Memorandum

Date:	April 24, 2024
To:	Honorable Mayor and Councilmembers
From:	Kathie Brooks Interim City Manager
Department:	Michelle M. Lopez The Corradino Group Interim Planning & Zoning Director
Subject:	Doral Marketplace Retail Center Variance – Parking row landscape strip reduction from 7.5 feet to 0 feet. (Variance Request # 2)

Figure 2. Landscape Strips (Local Shopping Center – Primary Grocery Tenant)

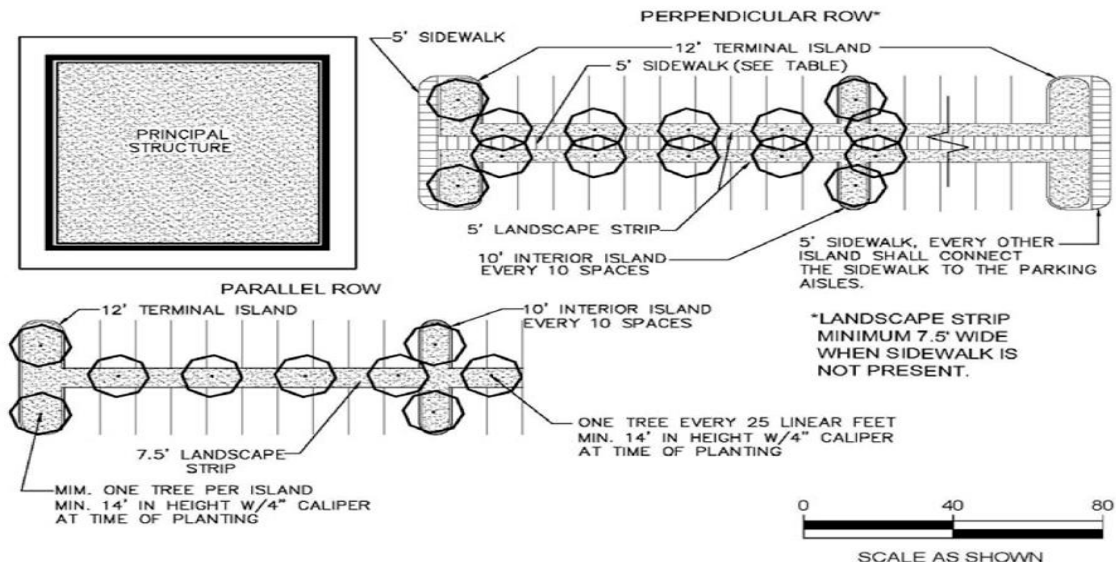
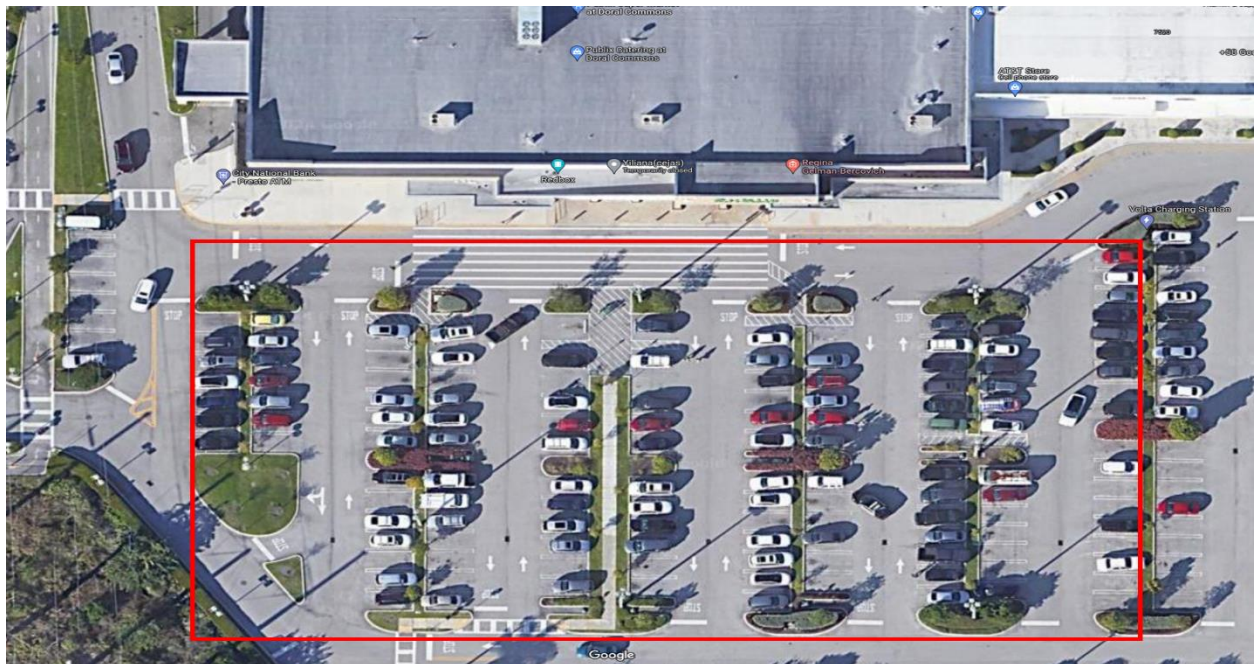
- a. Landscape strip reduction at four parallel rows of parking stalls adjacent and perpendicular to adjacent to the primary grocery tenant building, from 7.5-feet to 0 feet (a total reduction of the landscape strip in each row of parking stalls)

Planning and Zoning Department Response. The existing configuration of the property does not meet the definition, nor it shows any signs of being an irregular shape lot requiring the approval of a variance to grant the developer a relief from the requirements of Section 53-468(b), Land Development Code. The Applicant can address the landscape requirements in Section 77-193(2)(d), Landscaping and Buffers in the Land Development Code by modifying the proposed design of the buildings. The intent of Section 77-193 of the Land Development Code is to ensure that parking lots in the city provide landscaping to soften the impact of asphalt or other pavement on the overall appearance of the commercial use, prevents soil erosion, and reduces carbon dioxide through photosynthesis. The landscape strips requirements in Section 77-193(2)(d) of the Land Development Code is the bare minimum required by the city to mitigate the amount of heat absorbed by a parking lot released throughout the day and into the evening hours when the sun goes down. As a result, a parking lot without the appropriate landscaping can easily become a mini-urban heat island affecting the elderly, children and residents suffering from poor health. It is important to note that an effective environmentally landscape program will naturally alleviate the proposed project potential stormwater impacts.

Planning and Zoning Department Response. The Department disagrees with the Applicant position that this request is due to the narrow geographic shape of the lot. The configuration of this lot does not pose the basic characteristic of an irregular shape lot for which a variance could be considered by the elected body. Therefore, the issue here is not the land but the size of the buildings that can be slightly modified to avoid this variance.

Planning and Zoning Department Response. The literal interpretation and enforcement of the development code regulations would not deprive the applicant of rights commonly enjoyed by other properties in the same zoning district under the terms of the development code and would work unnecessary and undue hardship on the applicant. The Applicant does not meet the requirements of this criterion because there are no hardships associated with the land to justify granting a relief from the requirements of the Land Development Code (Section 77-193(2)(d), Landscaping and Buffers)

Planning and Zoning Department Response. This variance request does not meet the basic requirements of this criterion. As indicated above, the existing configuration of the lot would not prevent the Applicant from meeting the requirements of Section 77-193(2)(d) of the Land Development Code.

Planning and Zoning Department Response. The granting of this variance request will confer on the applicant special privilege that is denied by the land development code to other lands, buildings, or structures in the same zoning district. The other developments within the general vicinity of the Doral Marketplace development are building their respective projects consistent with Section 77-193(2)(d) of the Land Development Code.

Planning and Zoning Department Response: The granting of this request will not be in harmony with the general intent and purpose of Section 77-193(2)(d) of the Land Development Code.

It is important to note that the original variance request, dated January 24, 2024, as mentioned above, the Applicant had requested reduction at four parallel rows of parking stalls adjacent and perpendicular to the primary grocery tenant building, from 7.5-feet to 0 feet, where 7.5-foot landscape strip is required for each parking row pursuant to Section 77-193(2)(d) of the City Land Development Code. The proposed variance eliminates basically all landscape strips within the parking area serving the primary grocery tenant (Major Tenant A) and replace them with a limited number of tree planter (diamonds shape), which is not consistent with the requirements in Section 77-193(2)(d) and Section 71-213(3) of the City’s Land Development. Although this alternative is better than previous proposals, the adverse impact of these planters on the length of parking space may create a potential safety issue. The trees need to be planted within the landscape strips along with other plants and shrubs that are drought tolerant, minimize stormwater runoff impacts and contribute to the aesthetic value of the project (i.e. maintains the appearance of the property while giving the parking lot a more appealing look). As mentioned, the City Code’s landscape strips are the bare minimum requirement by the city to mitigate the amount of heat absorbed by a parking lot released throughout the day and into the evening hours when the sun goes down. As a result, a parking lot without the appropriate landscaping can easily become a mini-urban heat island affecting the elderly, children and residents suffering from poor health.

Staff recommendations consideration of the proposed variance request. While the application does not meet the hardship criteria requirements set forth in City Code Section 53-468(b) of the Land Development Code for the City, the Applicant has proffered alternatives in an effort to mitigate the impacts.

If the Variance request is Approved, the Applicant shall provide pervious pavers where landscape islands are required by City Code. The proffer is intended to minimize negative impacts to stormwater drainage and percolation. The landscape plan provides for trees and landscaping throughout the parking areas, added to overall aesthetics and minimizing overall heat island effects and creating a desirable tree canopy.
